TITLE RECTIFY TRACK SKIPPING				PIB NO. DK3054 A										
PRODUCT LINE:	TAPE DISK FORMATTER X	EQUIPMENT CHANGED SERVO PCBA 102811	MODEL SERIES AFFECTED D3000	EFFECTIVE DATE August 15, 1976										
CLASS OF BULLETIN:		ORDER PART KIT NO.	EFFECTIVITY											
<input type="checkbox"/> IMPROVEMENT <input checked="" type="checkbox"/> RETROFIT ON FAILURE <input type="checkbox"/> RETROFIT RECOMMENDED <input type="checkbox"/> SERVICE INFORMATION ONLY		N/A	All D3000 disk drives											
<p><u>PURPOSE</u></p> <p>To prevent track skipping due to spurious noise signals.</p> <p><u>SYMPTOMS</u></p> <p>Positioner skips tracks, giving address errors.</p> <p><u>PARTS REQUIRED</u></p>

TITLE RECTIFY TRACK SKIPPING

PIB NO.
DK3054A

FIGURE 1

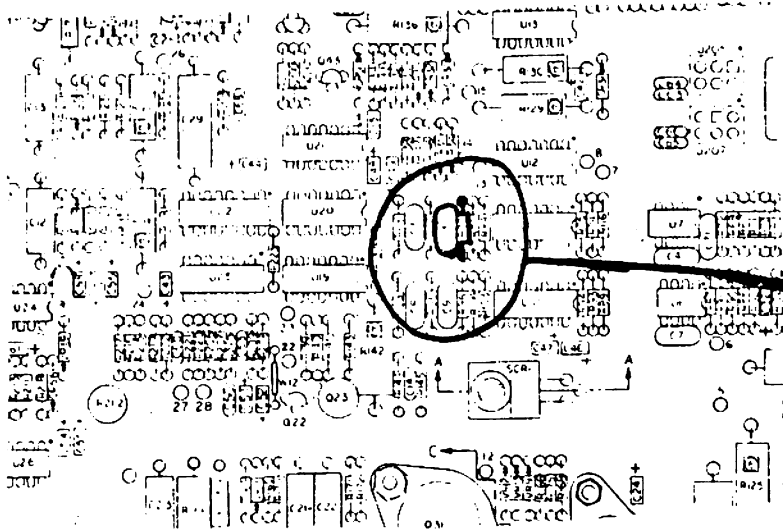
<p><u>SPECIAL TOOLS</u></p> <p>Low wattage soldering iron.</p> <p><u>REWORK INSTRUCTIONS</u> (A)</p> <ol style="list-style-type: none"> 1. Locate R77 and C5 on servo PCBA, see Figure 1. 2. Remove R77 and install new resistor 4.7K 3. Remove C5 and install new capacitor .0047 MFD. ← (A) <p><u>ADJUSTMENTS</u></p> <ol style="list-style-type: none"> 1. Repeat para. 6.8.2 (X+90 balance) of Operating and Service Manual. 2. Repeat para. 6.9.8. (Seek Time Final Adjustment). 						QTY	DESCRIPTION	PERTEC P/N	1	4.7K ohm \pm 5%, 1/4 watt	100-4725	1	.0047 MFD, \pm 10%, 100 WVDC	131-4720 ← (A)
QTY	DESCRIPTION	PERTEC P/N												
1	4.7K ohm \pm 5%, 1/4 watt	100-4725												
1	.0047 MFD, \pm 10%, 100 WVDC	131-4720 ← (A)

DRAWING CHANGE: Drawing 102810, sheet 1, zone 12E

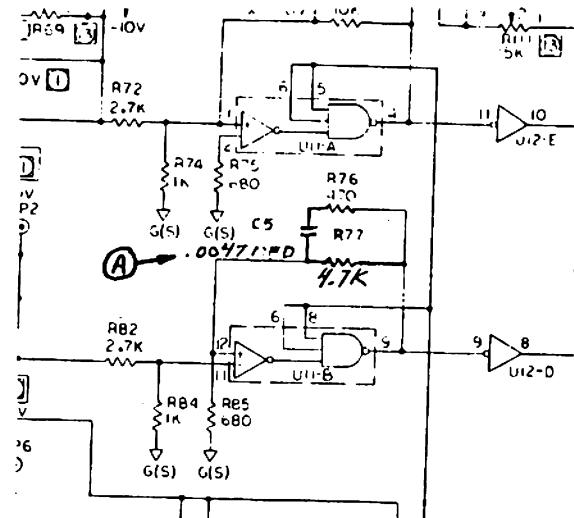
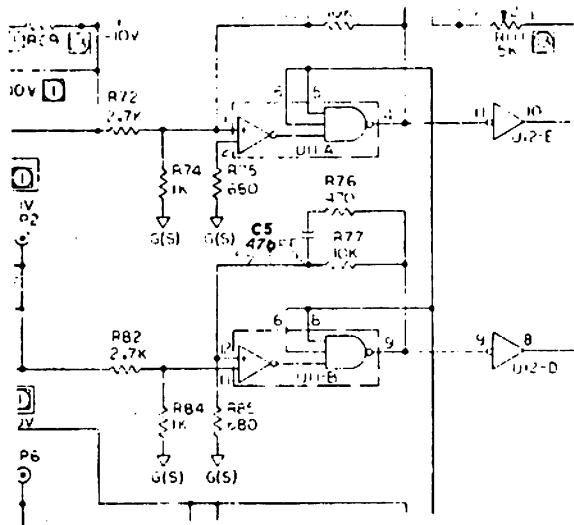
FROM:

TO:
